OSM/IN DECISION

Standard: EN 60730-1:2000 + A12:2003 + A1:2004 + A13:2004 + A14:2005 + A15:2007 + A16:2007 + A2:2008	Sub clause: 10.1.4, 10.1.5, 19.1, figures 10 to 13	Sheet N°: OSM/IN 260
Subject: Torque applied to terminals mounted on a printed circuit board and what conductor sizes may be specified	Key words: - Torque - Terminal - Printed circuit board	Meeting N°: 20 (2010) Item: 6.1

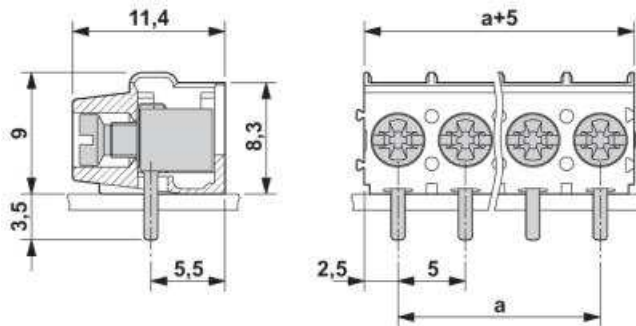
Questions: What torque should be applied to terminals blocks of the following style soldered onto printed circuit boards and what conductor sizes may be specified?

Question 1: This type of printed circuit board terminal block is not described in the definitions associated with the standard. Are they 'screw' terminals, or pillar terminals?

They do not clamp the conductor under the head, as shown in the screw terminal examples in fig. 10. They are similar in shape to the pillar terminals shown in fig. 11, however the head of the screw is retained in the moulding and they do not comply with all of the sizes shown in fig. 11 e.g. 'Minimum diameter conductor space (D)'. So, do these terminals have to conform to the other requirements shown in fig. 11 e.g. minimum diameter of conductor space 'D' or maximum gap between restraining parts 'e', or not?

If these are screw terminals (using as an example a 3mm size screw), the torque applied is 0.5 Nm (table 19.1). If, however, they are pillar terminals (again using a 3 mm size screw), the torque applied is 0.8 Nm. Does this mean however the terminals are declared, they must withstand the higher torque?

Standard: (See page 1)	Sub clause: 10.1.4, 10.1.5, 19.1, figures 10 to 13	Sheet N°: OSM/IN 260
Subject: (See page 1)	Key words: (See page 1)	Meeting N°: 20 (2010) Item: 6.1
Decision 1:	According to 10.1.5.1, the torque value for 16 A shall be according to table 19.1 or according to figures 10-13, <u>whichever is greater</u> . When this is followed, the above mentioned terminal shall be torqued with 1,2 Nm when it is a Screw-terminal and with 0,8 Nm, when it is a Pillar terminal. This style of terminal is to be tested to the requirements for pillar terminals, using the greater value of torque specified.
